UNITED STATES PATENT AND TRADEMARK OFFICE

APPLICATION NO.	FILING DATE	FIRST NAMED INVENTOR	ATTORNEY DOCKET NO.	CONFIRMATION NO.
10/660,067	09/11/2003	Bart De Laender	40987	6186
38505	7590	08/06/2007	EXAMINER	
MICHAEL W. TAYLOR			WILKENS, JANET MARIE	
P.O. BOX 3791			ART UNIT	PAPER NUMBER
ORLANDO, FL 32802-3791			3637	
			MAIL DATE	DELIVERY MODE
			08/06/2007	PAPER

Office Action Summary	Application No.	Applicant(s)	
	10/660,067	LAENDER ET AL.	
	Examiner	Art Unit	
	Janet M. Wilkens	3637

Sheet 1 of 4

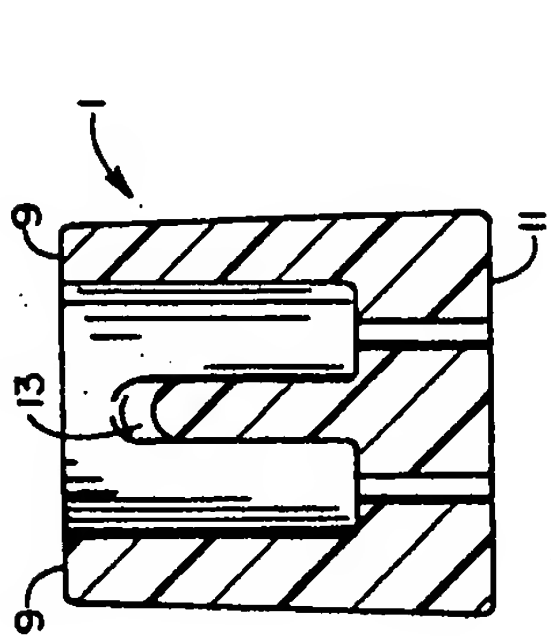
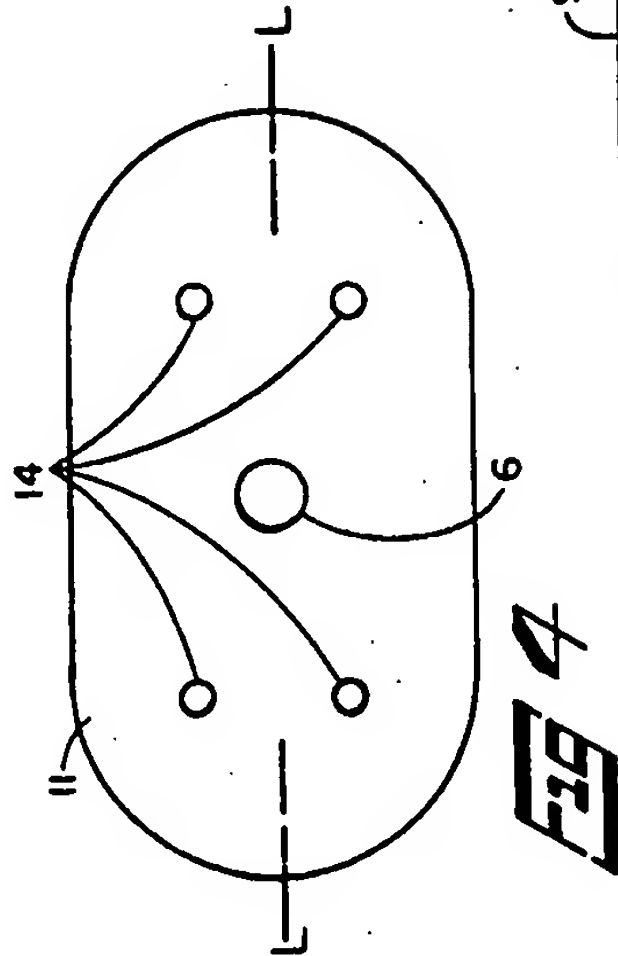
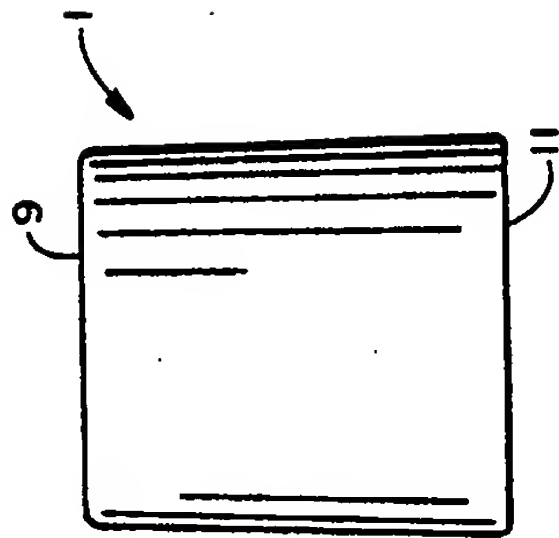
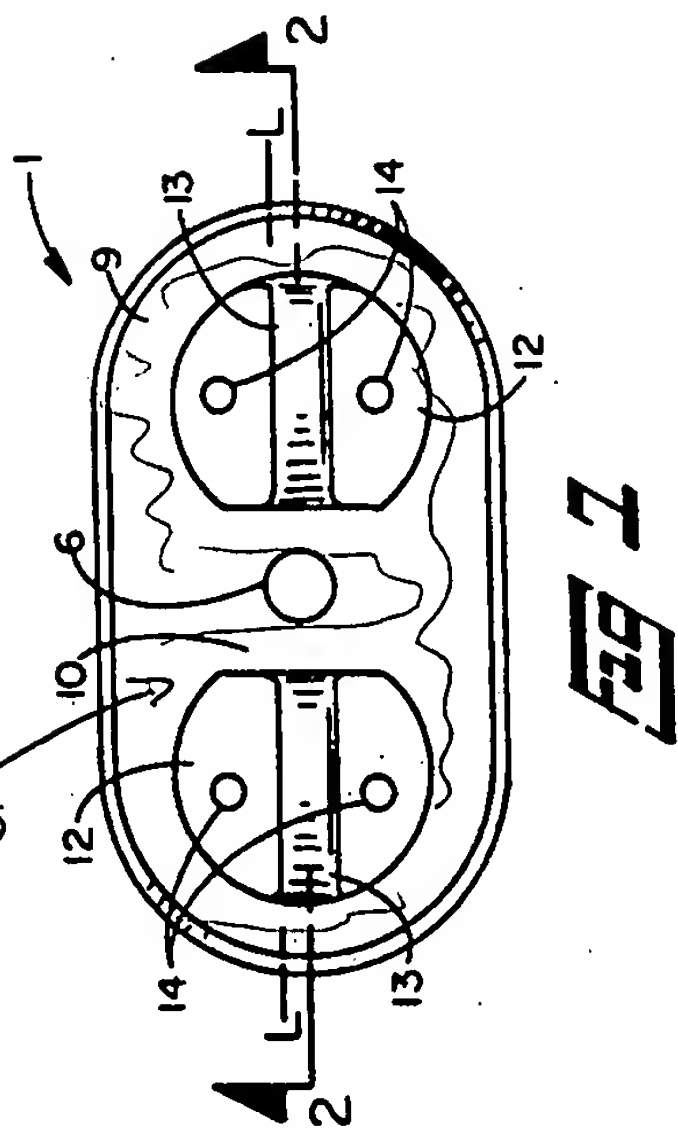
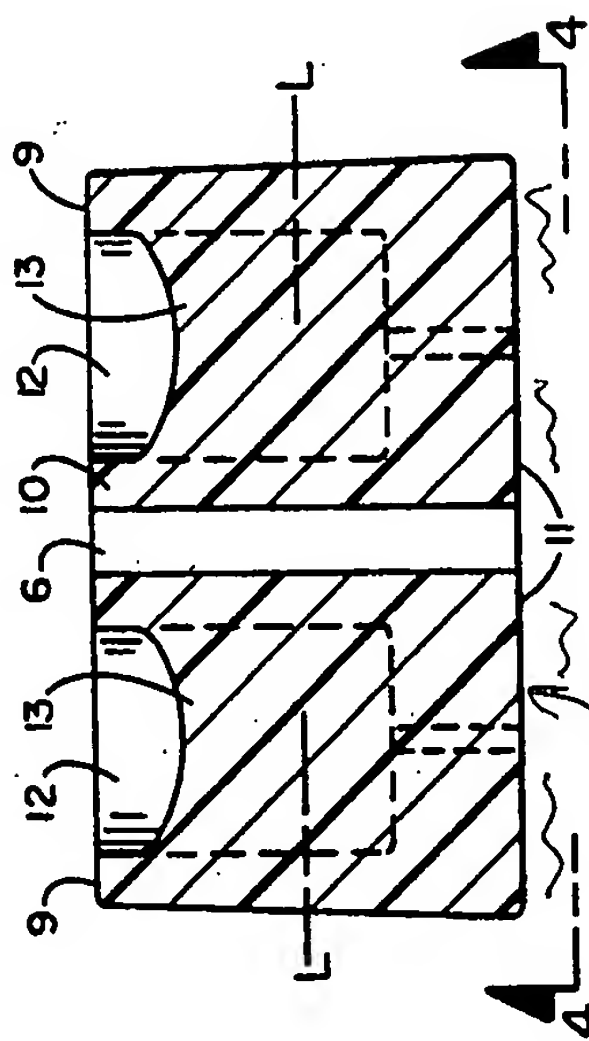
Addressing the art rejections over Ausavich: as stated above, limitations found in intended use/"for" statements are given no weight in the claims. Therefore, much of what is stated in claims 64 and 82 are not being considered as positively claimed. Furthermore, it is contended that the blocks of Ausavich do have upper and lower surface portions devoid of any openings (see Attachment A). Note: there is nothing in the claims that says that the entirety of the upper and lower surfaces are completely devoid of openings. Also, the fasteners being inserted into these portions are not being positively claimed as such.

no openings

no openings
